### Placerita Canyon Property Owners Association

### PCPOA ANNUAL ASSOCIATION MEETING JUNE 3, 2023

Re: Shadowbox Studios Project

Comments to Draft EIR

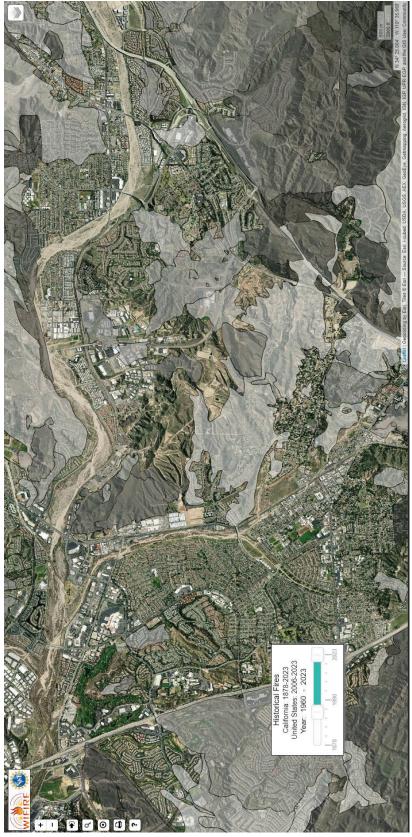
The EIR identifies that the average interval between wildfires within 5 miles of the project site is less than 1 year. This is a very high fire frequency rate.

The fire history, as corroborated by the EIR, clearly indicates that destructive wildfires will continue to threaten the Project area and the neighboring communities of Placerita Canyon and Circle J.
